Village of Arlington Heights
Plan Commission
Board Room
Arlington Heights Village Hall
33 S. Arlington Heights Road
Arlington Heights, IL 60005
October 25, 2017
7:30 PM

- A. St. Edna Church - 2525 N. Arlington Heights Rd. - PC#17-010
PUD Amendment

File Number: PC# 17-010
Project Title: St. Edna's Catholic Church
Address: 2525 N. Arlington Heights Rd.
PIN: 03-17-101-019

NEW ADDITION AND INTERIOR RENOVATIONS TO:
ST. EDNA CATHOLIC CHURCH
2525 N. ARLINGTON HEIGHTS RD. ARLINGTON HEIGHTS, IL 60004

NO.	DESCRIPTION	DATE
MECHANICAL DETAILS & SPECIFICATIONS		
DRAWING: AT, BC, KM		PLOT DATE: 05/01/2017
CHECKED: STT	M3.1	
JOB NUMBER: M16025

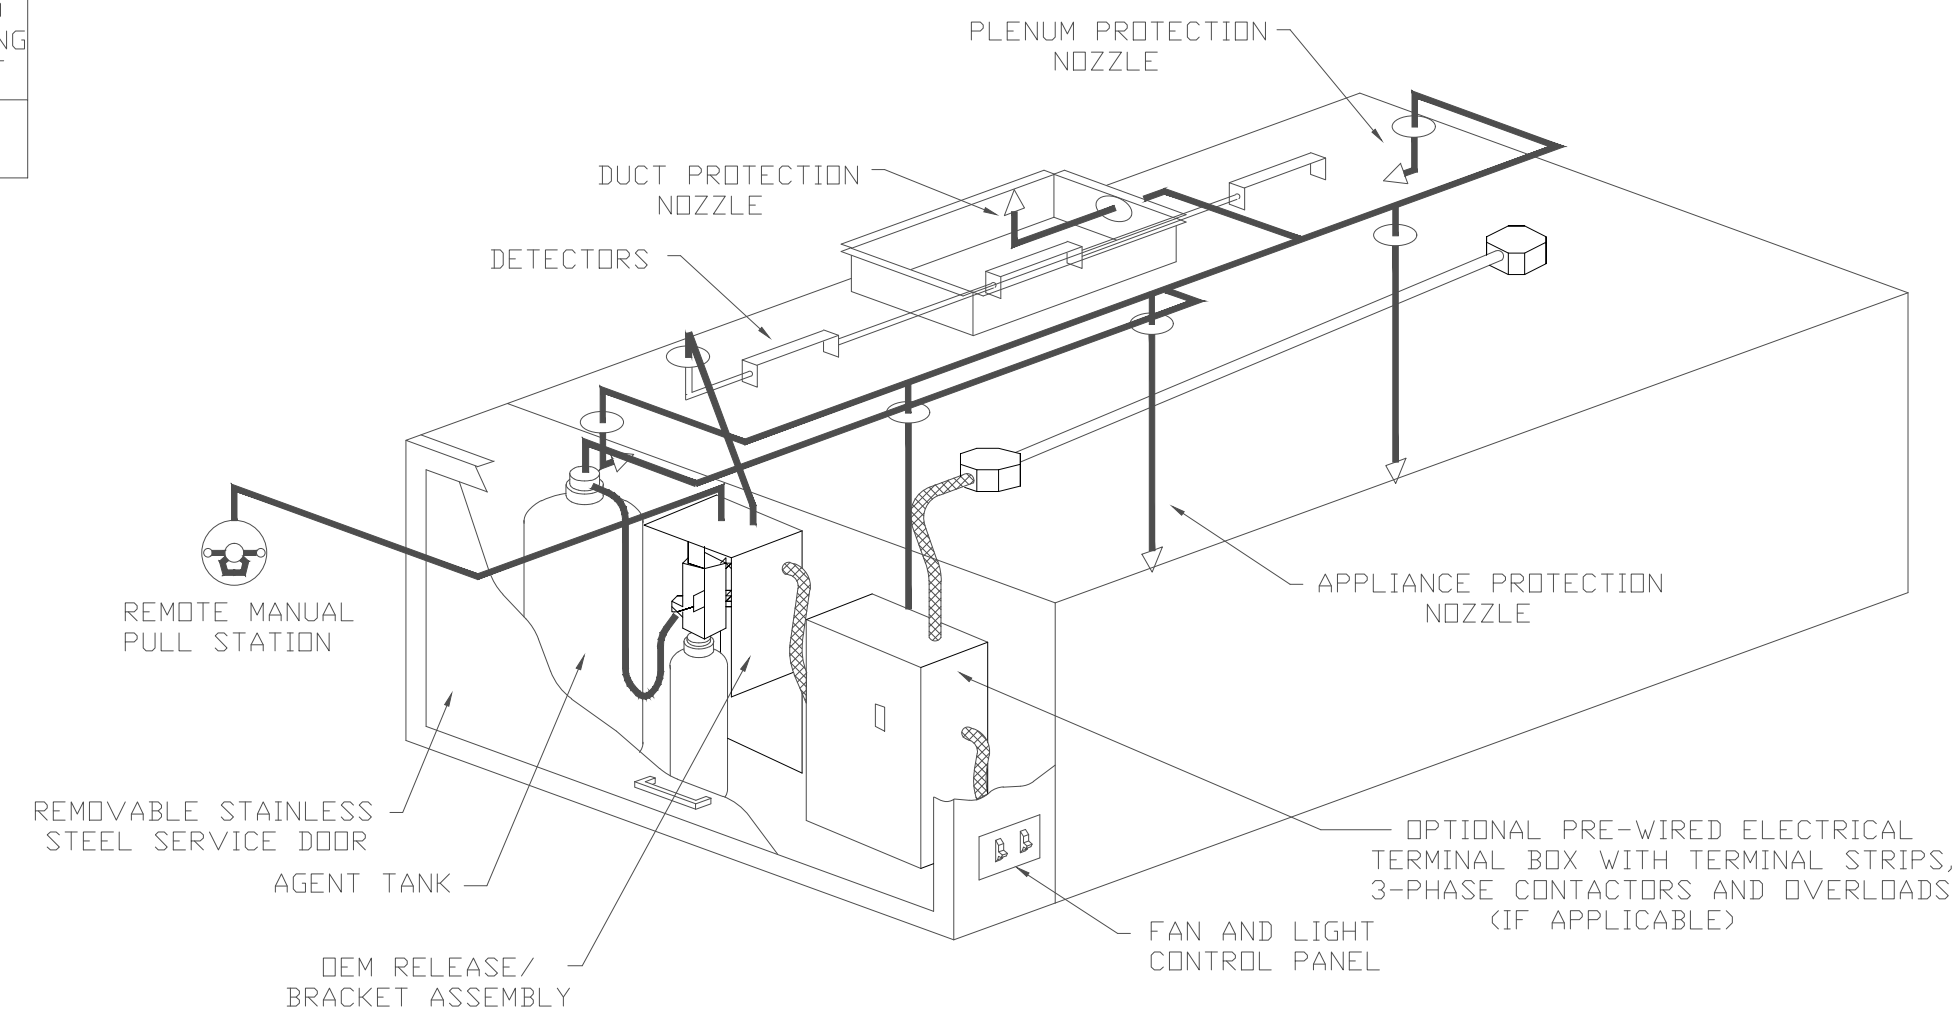
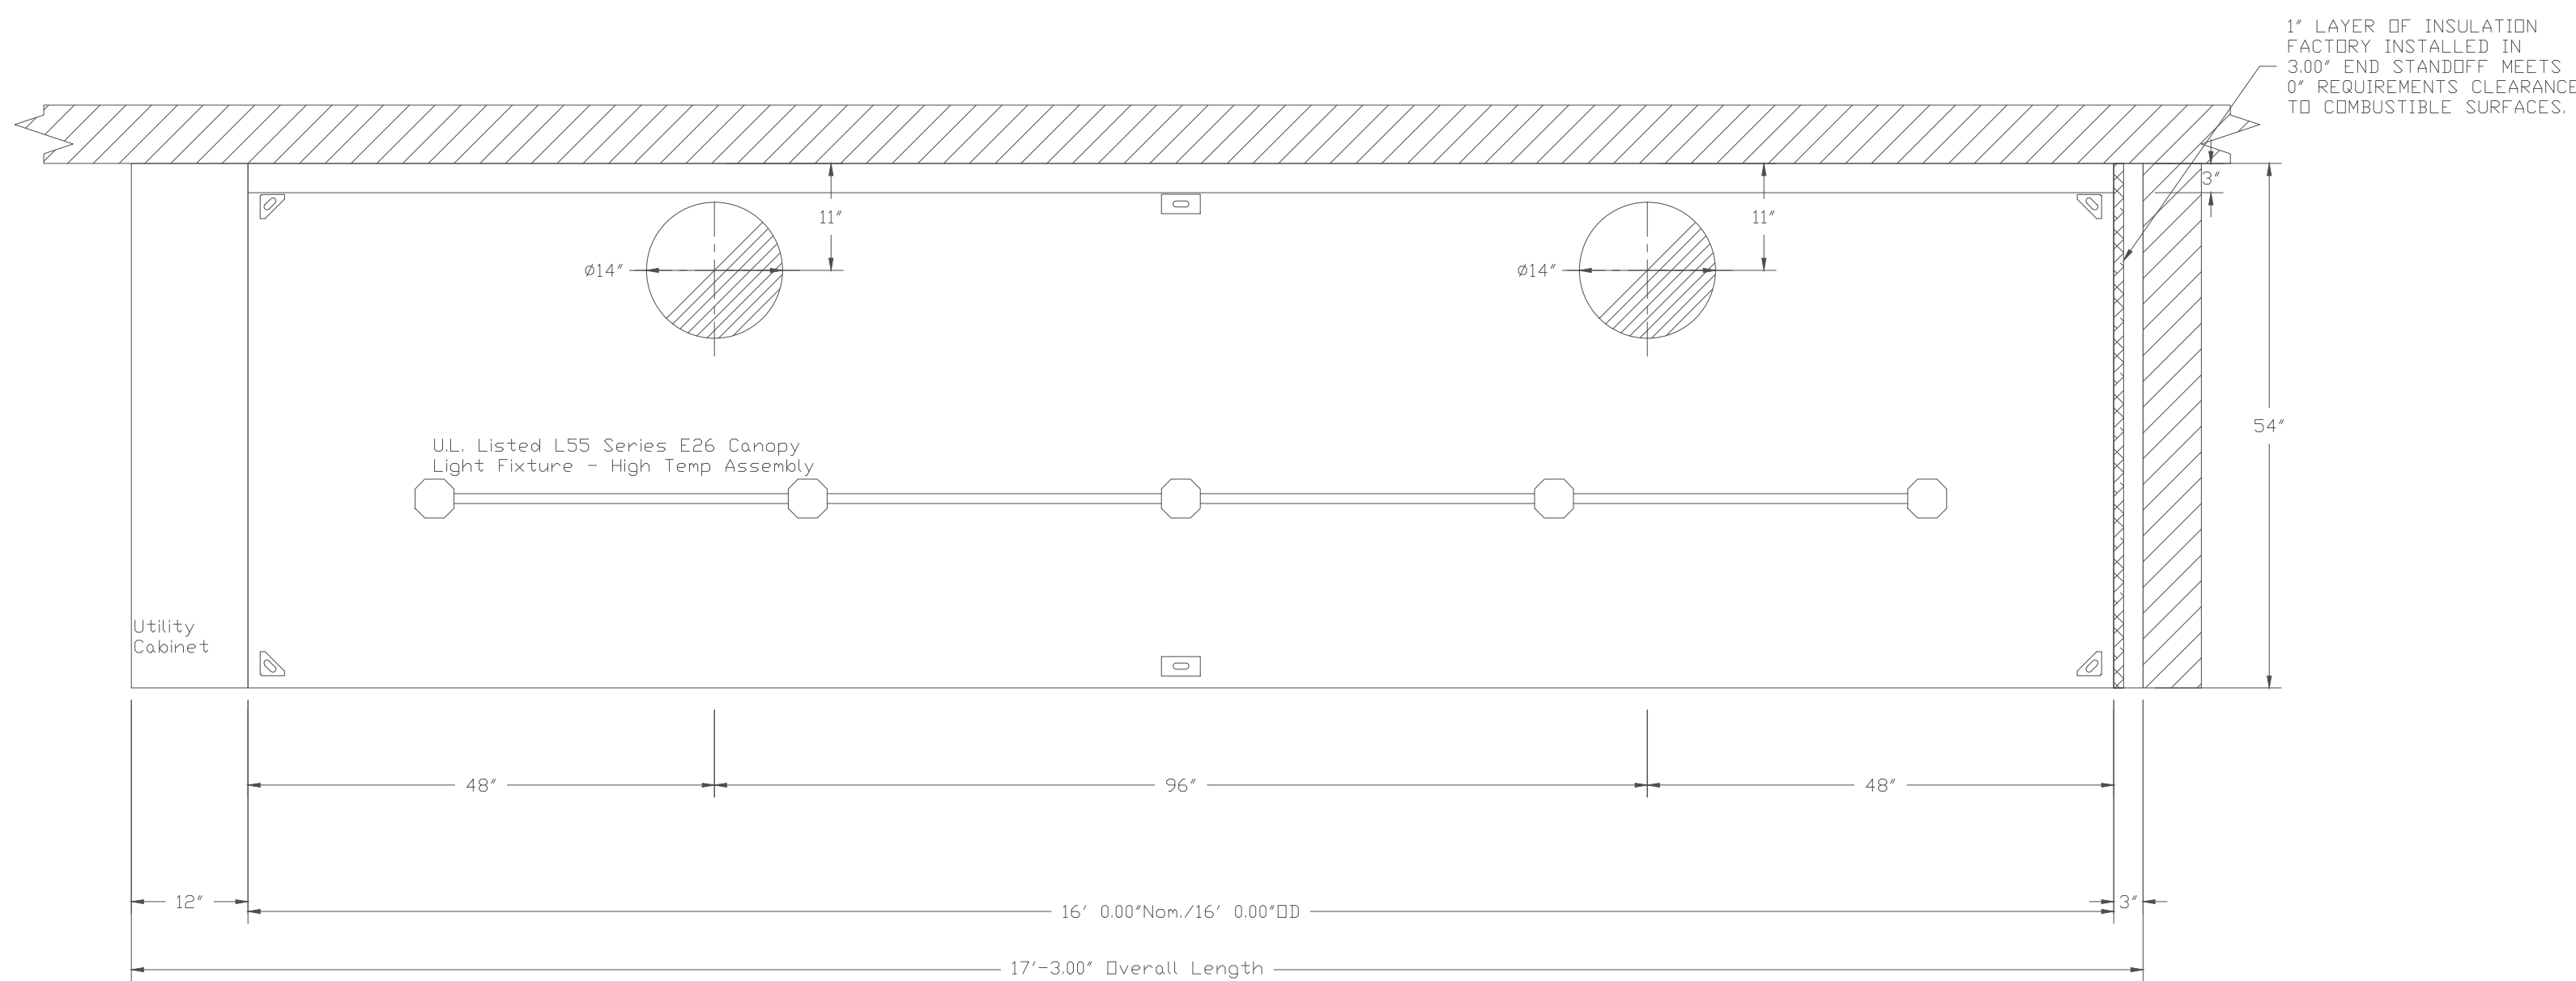
4. If the proposed kitchen will have cooking facilities a Hood and Duct fire suppression system may also be required.
A type 1 hood with a fire suppression system has been provided. See sheets M3.1 and M3.2 included as part of this response.
